**TSGENCO BHADRADRI NATURAL DRAFT COOLING TOWER ENQUIRY**

**TECHNICAL AMENDMENT -3**

**TECHNICAL SPECIFICATION NO.: PE-TS-411-165-N001 (REV.0)**

PROJECT: 4X270 MW BHADRADRI TPP

COOLING TOWER COLD WATER OUTLET  
WITH CT BASIN WATER LEVELS

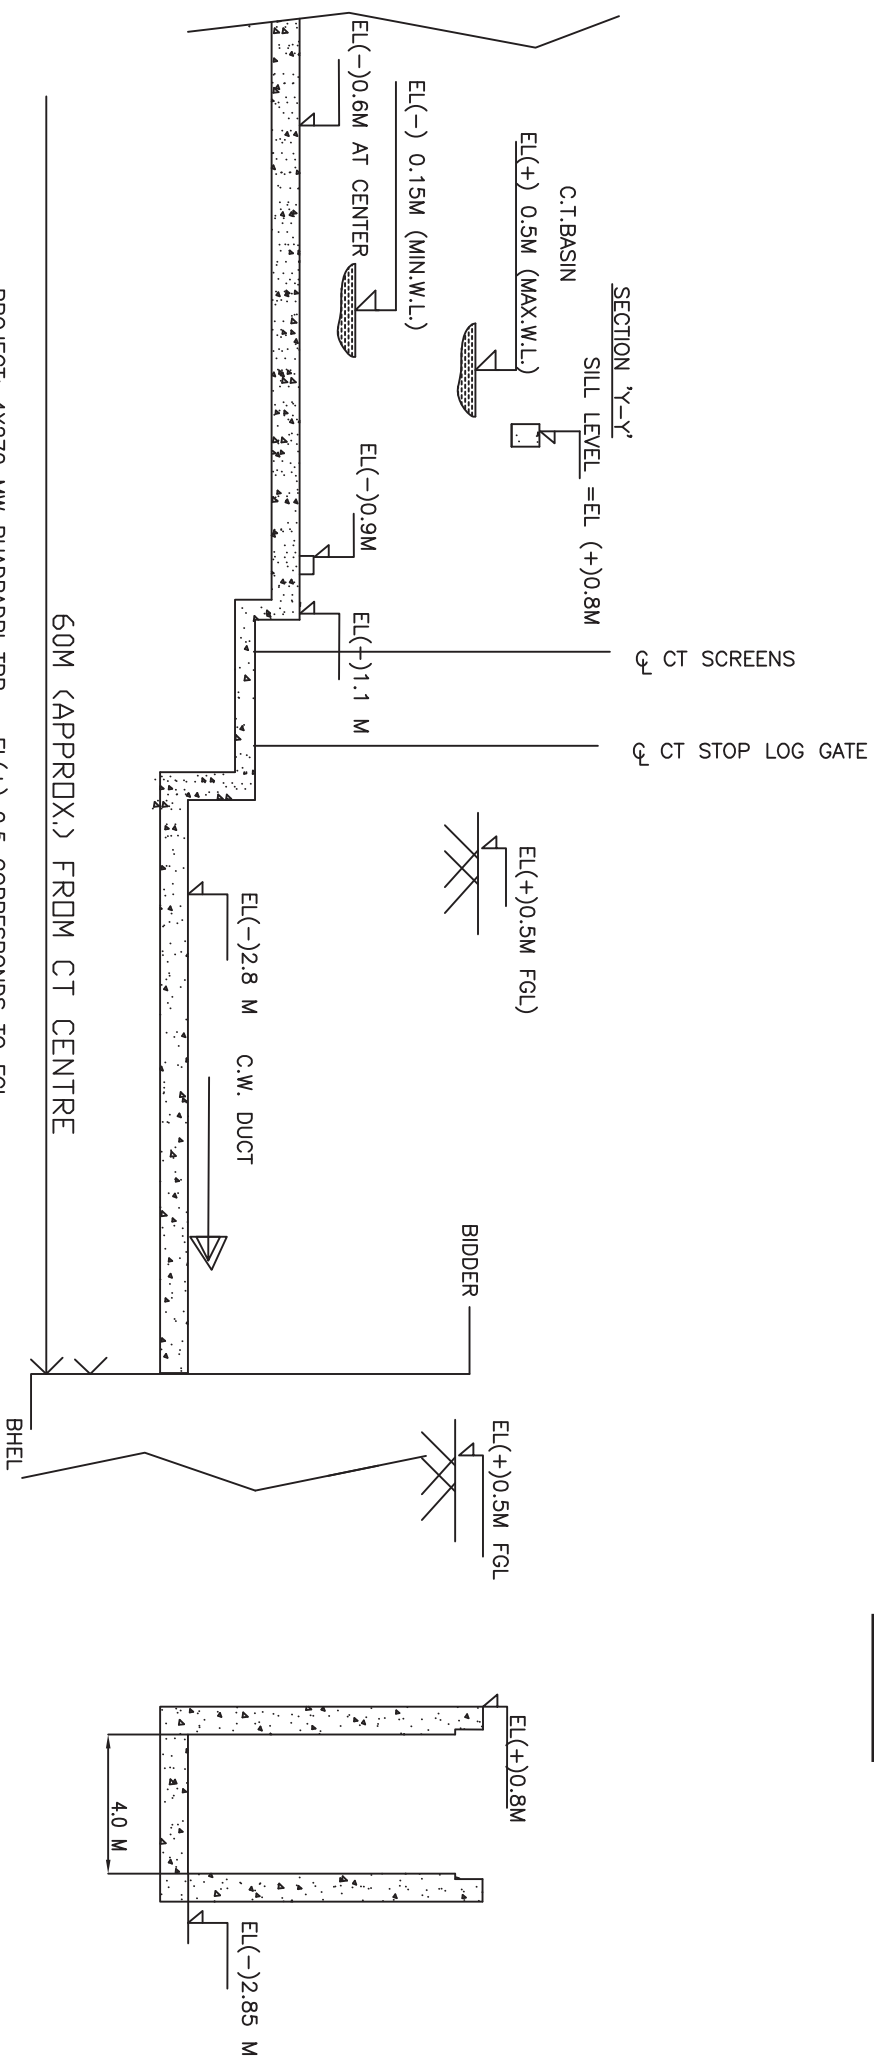
- 1) Clause # 4.10 – Section D1 (Datasheet A): The depth of CW Channel (w.r.t to FGL) shall be (-)3.35m instead of (-)4.1m stated earlier.
- 2) Clause # 4.12 – Section D1 (Datasheet A): The maximum allowable effective velocity through Cold water channel at Min. water level shall be 1.0 m/sec instead of 0.6 m/sec stated earlier.
- 3) Clause # 6.0 – Section D1 (Datasheet A): Hot water supply header details: The CW return piping size shall be 2400 NB instead of 2500NB stated earlier.
- 4) Section D1 (Datasheet A): Annexure-1: Sketch for Cold water channel TP: Revised Annexure-1 is enclosed.
- 5) Section D1 (Datasheet A): Annexure-2: Sketch for Key Plan with TP details: Revised Annexure-2 is enclosed.
- 6) Section C3 (Civil):The Amendment for Civil Section is enclosed in subsequent pages of this amendment.
